IWEA response to the consultations on EirGrid and ESB Networks' proposal for the general application of technical requirements in accordance with Articles 13-28 of the Commission Regulation (EU) 2016/631 establishing a network code on requirements for grid connection of generators

Comments on Section 4.2.2.2. Reactive Power Capability at Maximum Capacity: U-Q/PMax Profiles & Section 4.2.2.2.1 Article 18.2.b(i); SPM: Parameters required for U-Q/Pax Profiles

Sample 38kV Connection Method

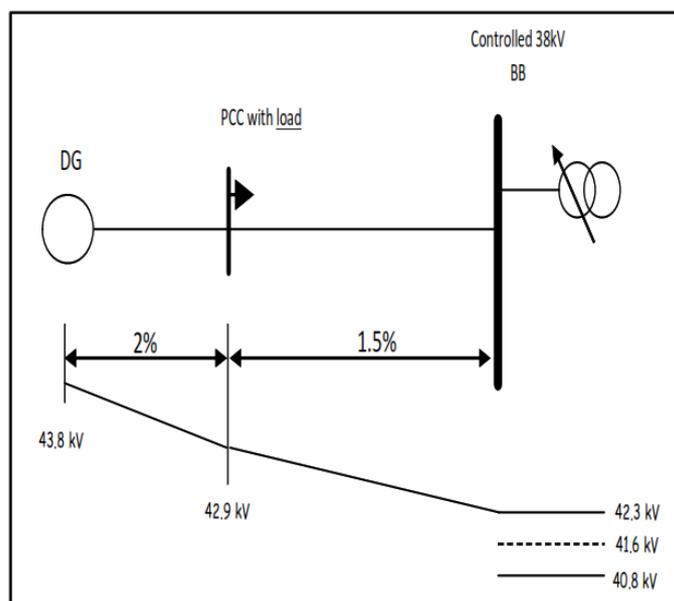
As Table 6a from the distribution code below shows, for the nominal voltage of 38kV, an operational voltage range of 35.6kV to 43.8kV is allowed. This is -6% and +15% from the nominal voltage. The sample 38kV connection diagram below also shows that ESB Networks usually have a voltage range of 40.8kV to 42.3kV at 38kV busbars, which is substantially higher than the nominal 38kV voltage. As mentioned above, the use of the wide voltage range, particularly at the upper end, is to allow for connection of demand on long distribution connections. It should be noted that 42.3kV, the higher end of the busbar voltage, is already above the 1.1pu. There appears to be similar issues for the medium voltages of 10kV and 20kV.

The IWEA strongly oppose the implementation of the new 1.1pu voltage limit at 38kV and MV. The IWEA request that at 38kV the current limit of 1.15pu or 43.8kV is maintained and at MV the 1.125pu or 22.5kV is maintained. IWEA believes that there may be some technical solutions of how to address the impact of the change to voltage limits in the network codes. For example, changing the nominal voltage from 38kV to 40kV. However, considering the potential interactions of a technical solution to the overall operation and design of the distribution system we believe that ESB Networks are best placed to review and advise on technical solutions.
